### **11.2.1 AMENDMENT TO KUDARDUP LOCAL STRUCTURE PLAN**

## MODIFIED STRUCTURE PLAN

### Lot 1 Kudardup Road, Kudardup

**SCHEDULE OF SUBMISSIONS – P218547**  
**Modification to Existing Kudardup Local Structure Plan**  
**Lot 1 Kudardup Road, Kudardup**

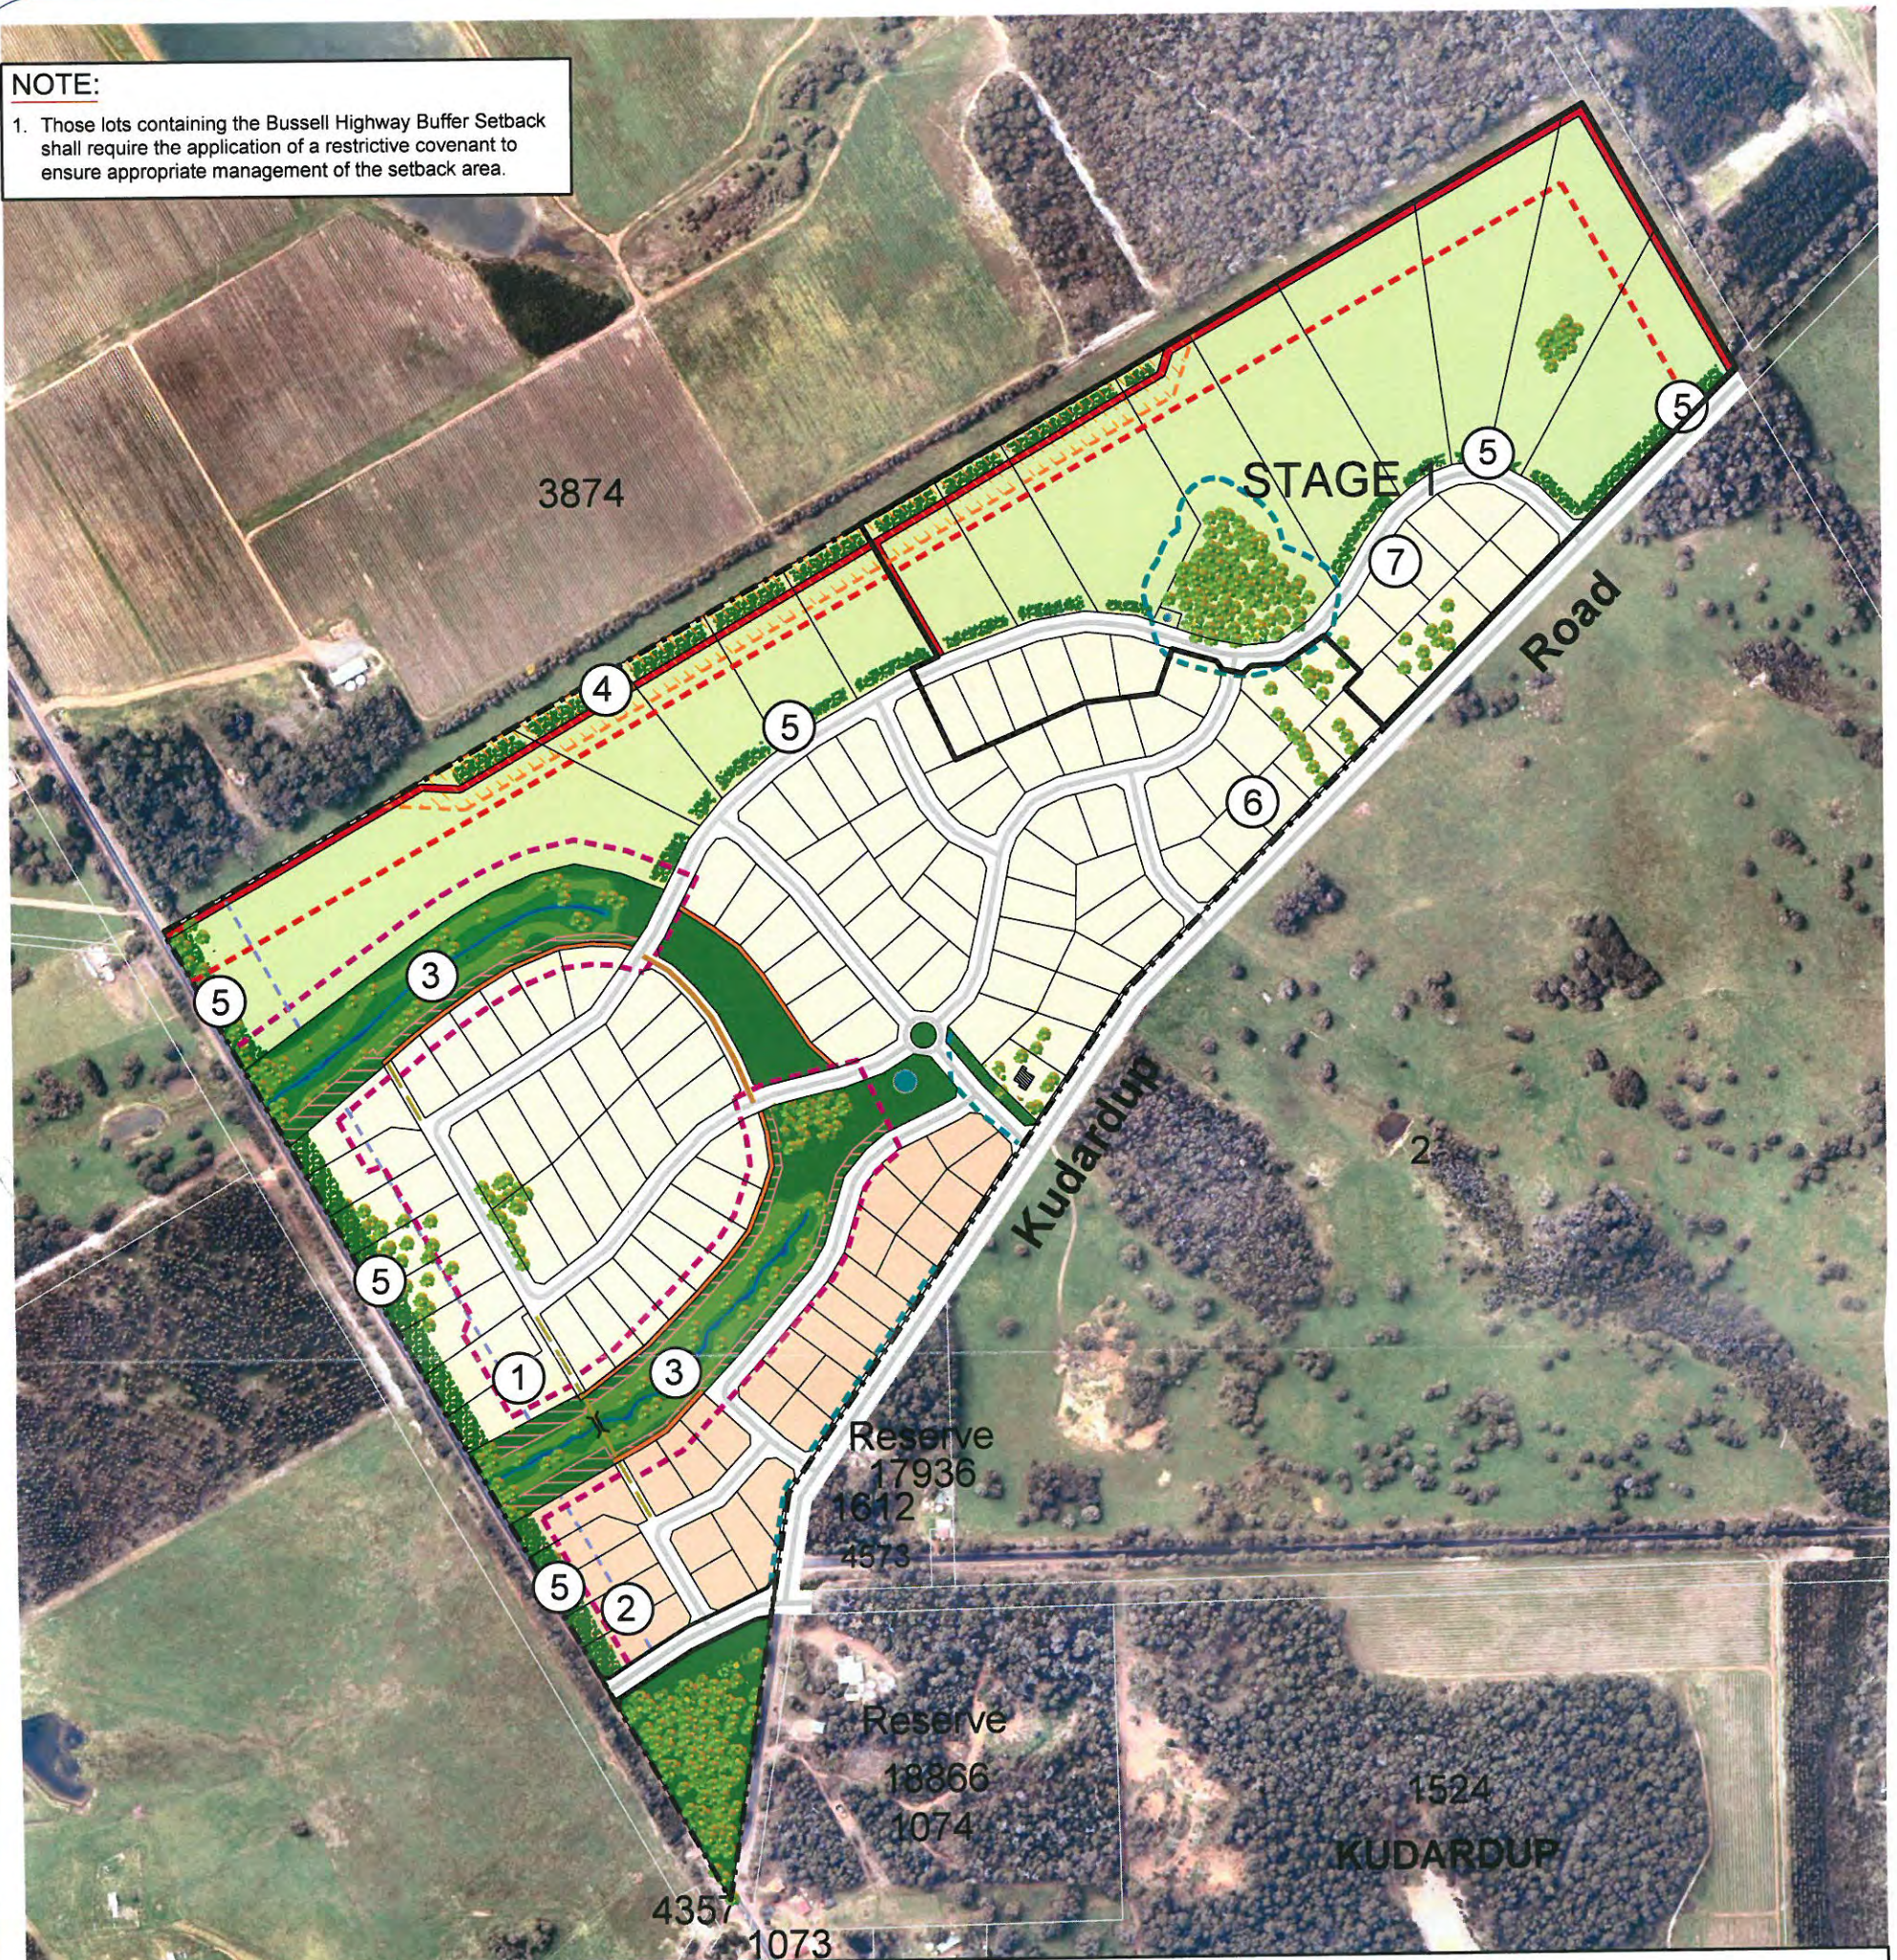
3.	Department of Water and Environmental Regulation	1. The main risk identified in this amendment relate to stormwater management, where a reduction in the POS is proposed that could be performing a bio-retention function. 2. To mitigate above risk the proponent should quantify what the alteration to stormwater volumes/retention would be and how this could be managed to the Shire's satisfaction.	Noted. The Shires engineering staff have advised that any issues and agreed solutions will be articulated via modifications to the UWMP prior to subdivision.	No change required.
<b>Landowner Submissions</b>

4.	Ian Ladyman 252 Kudardup Road Kudardup (adjoins subject property at north east boundary)	Object Potential to impact on peaceful enjoyment and ability to conduct farming enterprise.	Agree in part. The additional 3 x 2000m <sup>2</sup> lots are located well away from the submitters property and are unlikely to have any direct impact.	It is recommended that support for the proposal be conditional on there being no change to the number of rural residential lots.
